Rezoning Application: PD 23-0041

Zoning Hearing Master Date: June 20, 2023

APPLICATION NUMBER: PD 23-0041

Case Reviewer: Michelle Heinrich, AICP

8.0 PROPOSED SITE PLAN (FULL)

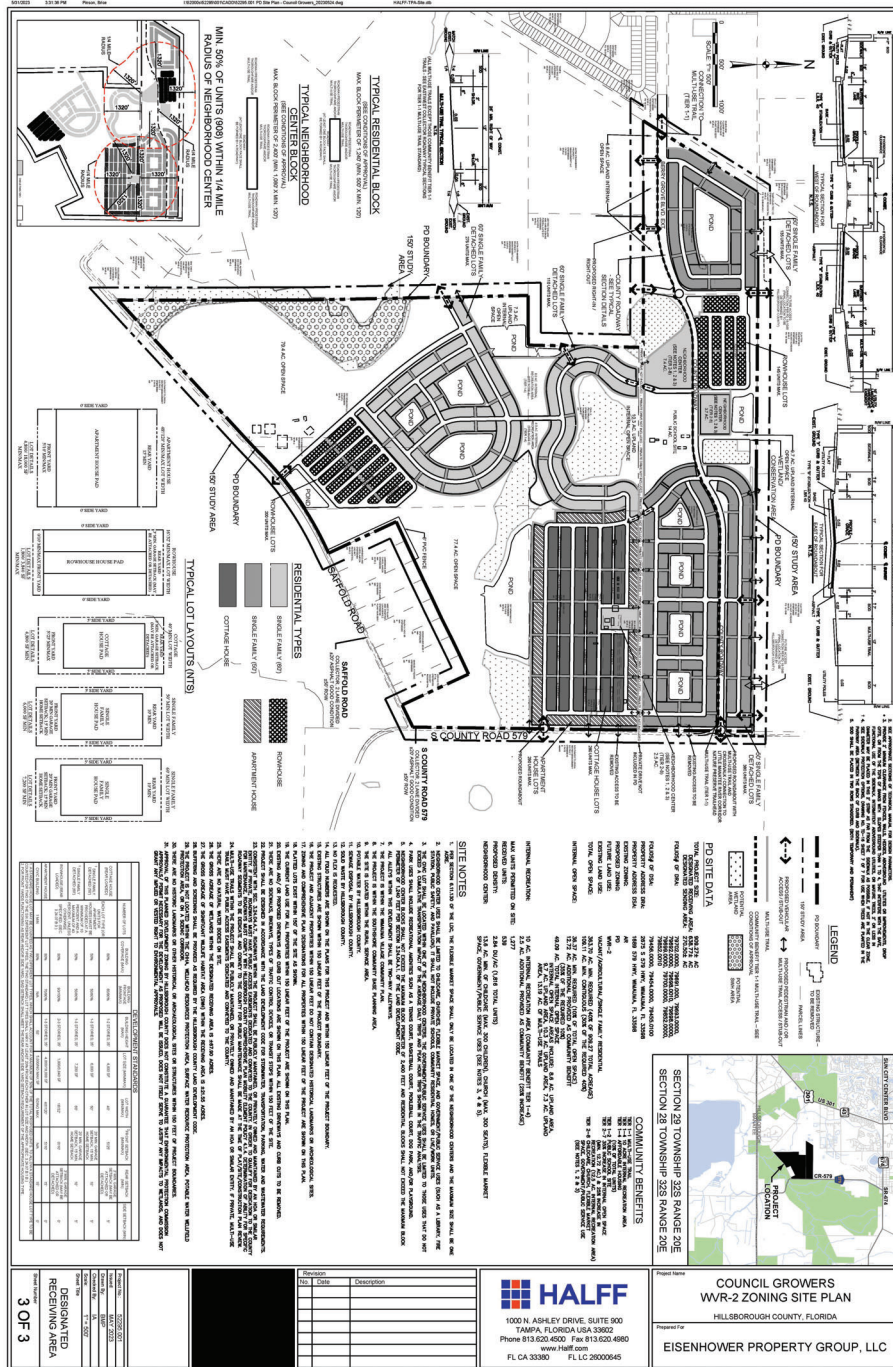
1. Typical Lot Layout shown on Sheet 2 of 3 (Sending Area) to be modified to be consistent with condition 9.
2. Typical Lot Layout for the Civic Building Lot Type to be provided on Sheet 3 of 3.

3. Development Standards table and Typical Lot Layouts to correct "Single-Family Detached" to "Standard House."
4. "Number of Units" column in the Development Standards table to reference the 10% minimum – 40% maximum for the Cottage House Lots, Rowhouse Lots and Apartment House House Lots; to reference the 10% minimum to 50% maximum for the Standard House Lots (combined); and to reference the 10% minimum to 40% maximum for the Civic Building Lot Type as not applicable.

7. Development Standards table to include the number of stories (1-4) for Civic Building Lots.
8. Development Standards table to provide the minimum-maximum lot sizes and minimum-maximum lot widths for the Cottage House Lot Types (both or one size/width) and Standard House Lot Types (both types), as provided in the Lot and Primary Structure Requirements by Lot Type (LDC Section 3.24.08).

9. Development Standards table to provide the number stories (1-4) for the Civic Building Lot.
9. Note #4 on Sheet 3 of 3 to replace "park" with "recreation."

10. The 8 acre and 4.5 acre "Internal Recreation Areas" to be re-labeled "Community Benefit Park and Internal Recreation Areas."
11. Community Benefit notations within the "Community Benefit Park and Internal Recreation Areas" to add Tier 2-7 to Tier 1-4.

12. "Note 6" to be removed from the 8 acre and 4.5 acre "Community Benefit Park and Internal Recreation Areas."
13. Tier 2-7 in the Community Benefits table in the PD Site Data to correct the internal recreation acreage from 12.5 to 2.5.

14. PD Site Plan Data to separate the required Internal Open Space acreage from the Community Benefits.
Internal Open Space:
 36.37 acres total: 8.6 acre upland area, 9.7 acre upland area, 10.3 acre upland area, 7.3 acre upland area and 0.47 acres of Multi-Use Trails, excluding the Multi-Use Trail provided under Community Benefit 1-1.

15. Proposed "Pedestrian and/or Multi-Use Trail access/stub-out" in the Legend to be modified to remove "Pedestrian and/or."
16. Site Plan to provide the following Site Note: Wetlands or other surface waters are considered Environmentally Sensitive Areas and are subject to Conservation Area and Preservation Area setbacks. A minimum setback must be maintained around these areas which shall be designated on all future plan submittals. Proposed land alterations are restricted within the wetland setback areas. Only items explicitly stated in the condition of approval or items allowed per the LDC may be placed within the wetland setback.

17. Prior to certification of the General Development Plan (GDP), the applicant shall revise Sheet 3 of 3 the GDP to:

- 17.a Remove the references to “Pedestrian Thoroughfare” within the “Typical Residential Block” and “Typical Neighborhood Center Block” portions of the site plan, as well as any other references which would suggest that such facilities could be permitted;

- 17.b In the rightmost typical section, remove the reference to (“Residential and Non-Residential”) from the top of the section and change to top label to read “69’ Min. Public Right-of-Way – See Conditions of Approval”. Staff notes that as a proposed urban collector roadway, these distinctions are meaningless in the TTM.

- 17.d In the rightmost typical section, change the label reading “Typical Section for East of Roundabout” to instead read “Typical Section for Berry Grove Blvd. Extension East of Internal Roundabout”.

- 17.e In the leftmost typical section, change the label reading “116’ Min Right-of-Way” to instead read “116’ Min. Public Right-of-Way – See Conditions of Approval”.

- 17.f In the leftmost typical section, change the label reading “10’ Utility, Landscape & Hardscape Easement” to instead read “10’ Utility, Landscape, Hardscape & Public Access Easement”.

- 17.g In the leftmost typical section, change the label reading “Typical Section for West of Roundabout” to instead read “Typical Section for Berry Grove Blvd. Extension West of Internal Roundabout”.

- 17.h In both typical sections, change the label reading “12’ Multi-Use Trail” to instead read “12’ Tier 1-1 Multi-Use Trail”.
- 17.i In the rightmost typical section, change the label reading “10’ Sidewalk” to instead read “10’ Multi-Purpose Trail”.

- 17.j Consistent with Development Review Procedures Manual Minimum Requirements (DRPM), the developer shall:
- i. Correct the locations of the access arrows depicting the location of approved access within adjacent PD 18-1048. Staff notes that the certified site plan for that project shows the their westernmost stubout along their southern boundary is location +/- 1,480 feet east of the western PD boundary, and their easternmost stubout along their southern boundary is located +/- 1,080 feet west of the eastern PD boundary. This project’s PD site plan is currently showing them located 740 feet and 530 from those respective boundaries.

- ii. Show and label the adjacent wetland systems to the north, as shown on the 18-1048 certified site plan and ensure they are drawn to scale.
 - iii. Show and label the Little Manatee Corridor Nature Preserve parking area/trailhead, and show those portions of the adjacent trail system within the PD study area (use an aerial to digitize in locations).

18. Modify the Typical Lot Layout for “Rowhouse” units to replace the label “3’ Min. Garage Setback (May Be Attached or Detached)” with a label reading “3’ Min. Garage Setback for Alley Accessed Units (May Be Attached or Detached)*”. Then add corresponding asterisk and note underneath that one typical lot layout which states, “*See Conditions of Approval for Minimum Rear Yard Setbacks for Rowhouse Units Accessed Via Rear Yard Adjacent Roadways”.

19. Modify the Development Standards table to:
- 19.a Change the label reading “Cottage House (Rear Loaded)” to instead read “Cottage House (Rear Alley Access Only)”.

- 19.b Change the label within the “Rowhouse (Rear Loaded)” row and “Rear Setback (Min)” column from “3’ Min. Garage Setback (May Be Attached or Detached)” to instead read “3’ Min. Garage

- Setback for Alley Accessed Units (May be Attached or Detached)³". Then add a 3rd footnote stating "3. See Conditions of Approval for Minimum Rear Yard Setbacks for Rowhouse Units Accessed Via Rear Yard Adjacent Roadways".

- 19.c Add the text "Lot Type" within the black box in the 1st column.
20. In the "PD Site Data" table, replace the "Neighborhood Center" portion of the table with a new table which reads as follows:

- 20.a Revise "Site Note" 3 to read "Neighborhood Centers shall be developed utilizing the Civic Building Lot standards.
- 20.b Add a new asterisk to the "Proposed Density" and new "Proposed Non-Residential Uses" portion of the table and add a footnote at the bottom of the PD Site Data Table which reads Uses within the project are subject to trip generation caps which apply separately between the Northern and Southern Receiving Areas– See Conditions of Approval".

- 20.c Add arrow symbology to the legend corresponding with the access arrows within adjacent PD 18-1048 and label as "Access within Adjacent PD 18-1048".

21. Add a new site note stating "Areas of additional right-of-way dedication and conveyance, as well as Corridor Preservation are not shown due to the graphic scale. Such areas are present along the project's CR 579 and Saffold Rd. frontages. See conditions of zoning approval for additional information."

Design Exception #1 – CR 579 Substandard Rd.

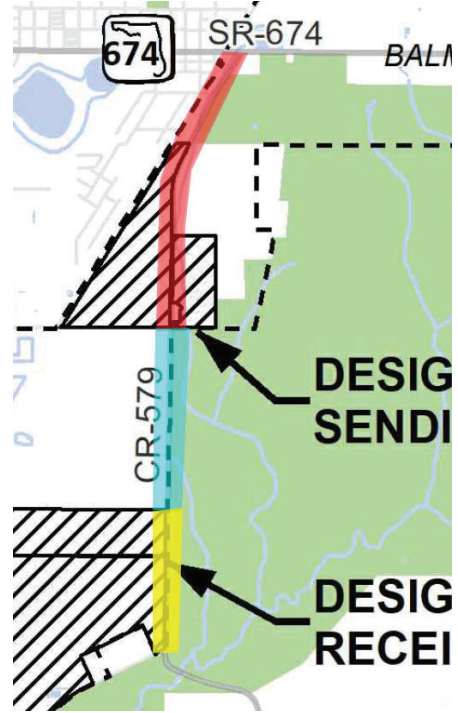
As CR 579 is a substandard collector roadway, the applicant’s Engineer of Record (EOR) submitted a Design Exception request (dated April 24, 2023) to determine the specific improvements that would be required by the County Engineer. Based on factors presented in the Design Exception request, the County Engineer Found the request approval (on May 30, 2023), determined it to be in compliance with LDC Sec. 3.24.06.D.1.a.. and recommended the BOCC find the Design exception is appropriate. The deviations from the Transportation Technical Manual (TTM) Typical Section – 7 (TS-7) (for 2-Lane, Rural Local and Collector Roadways) include:

1. Within Segment A (depicted in the graphic below in red), which shall be defined as that portion of CR 579 between SR 674 and the southern boundary of the Sending Area:

- a. The developer will be permitted to maintain the 10 to 11-foot-wide existing lanes in lieu of the 12-foot-wide lanes required pursuant to the Typical Section – 7 (TS-7) of the Transportation Technical Manual (TTM);

If PD 23-0041 is approved by the BOCC, the County Engineer will approve the above referenced Design Exception request, subject to certain revisions as described in the proposed “Prior to Certification” conditions included hereinabove.

Design Exception #2 – Saffold Rd. Substandard Rd.

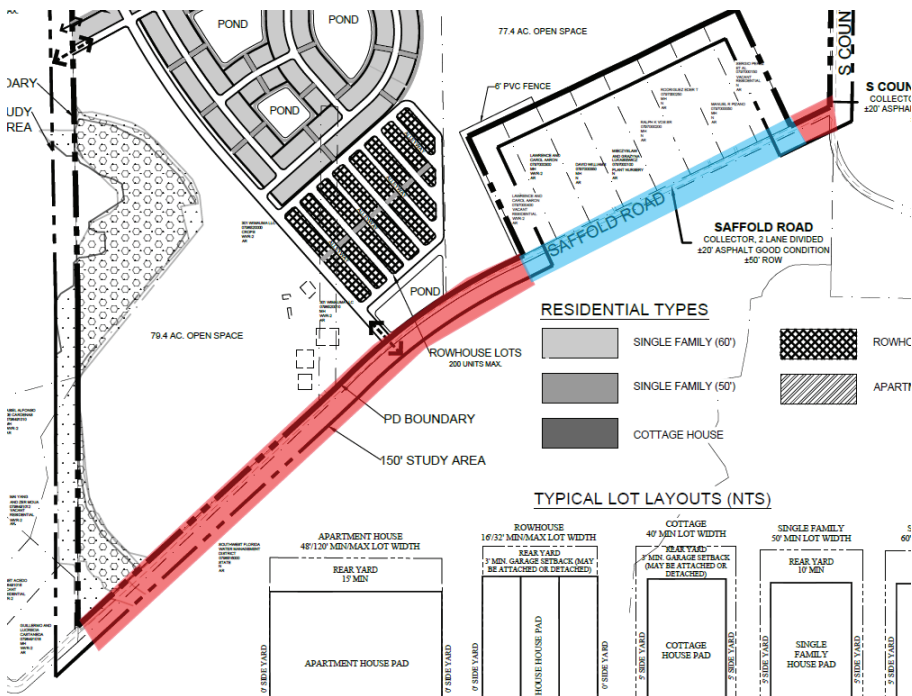
As Saffold Rd. is a substandard collector roadway, the applicant’s Engineer of Record (EOR) submitted a Design Exception request (dated April 24, 2023) to determine the specific improvements that would be required by the County Engineer. Based on factors presented in the Design Exception request, the County Engineer Found the request approval (on May 30, 2023), determined it to be in compliance with LDC Sec. 3.24.06.D.1.a.. and recommended the BOCC find the Design exception is appropriate. The deviations from the Transportation Technical Manual (TTM) Typical Section – 7 (TS-7) (for 2-Lane, Rural Local and Collector Roadways) include:

1. Within Segment B (depicted in the graphic below in blue), which shall be defined as that portion of Saffold Rd. along the frontages of folios 79700.0400, 79700.0300, 79700.0350, 79700.0100, 79700.0200, 79700.0250, 79700.0050, and 79700.0150:
 - a. The developer will be permitted to maintain the 10-foot-wide existing lanes in lieu of the 12-foot-wide lanes required pursuant to the TS-7 of the TTM;
 - b. The developer will be permitted to construct 6-foot-wide stabilized shoulders along both sides of the roadway, in lieu of the 8-foot-wide stabilized shoulders required pursuant to TS-7 of the TTM; and,
